**Committee of Experts on the Transport of Dangerous Goods
and on the Globally Harmonized System of Classification
and Labelling of Chemicals****Sub-Committee of Experts on the Transport of Dangerous Goods****Forty-second session**

Geneva, 3 – 11 December 2012

**New proposals for amendments to the Model Regulations
on the Transport of Dangerous Goods****Excepted Quantity provisions regarding the use of absorbent
material and marking****Transmitted by the International Council of Chemical Associations
(ICCA)¹****Introduction**

Figure 3.5.2

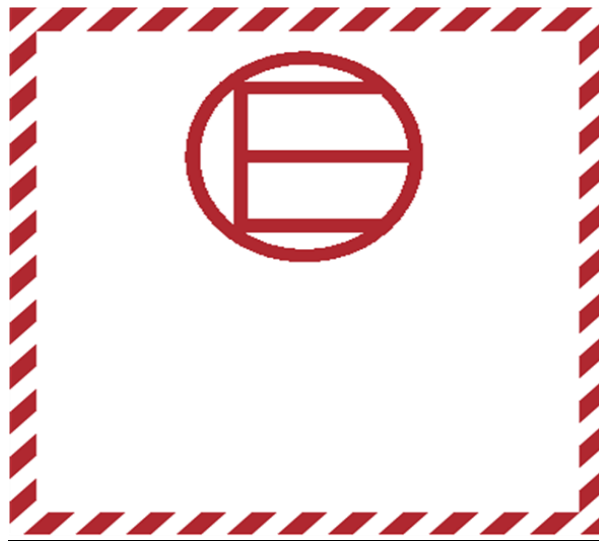
In case the number of packages exceeds 1000 or the number of packages is not counted, the transport units shall be marked with the mark shown in Figure 3.5.2 at the positions required for placards except when placards or marks in accordance with chapter 5.3 are displayed.

The dimensions of the placard shall be a minimum of 200 x 200 mm.
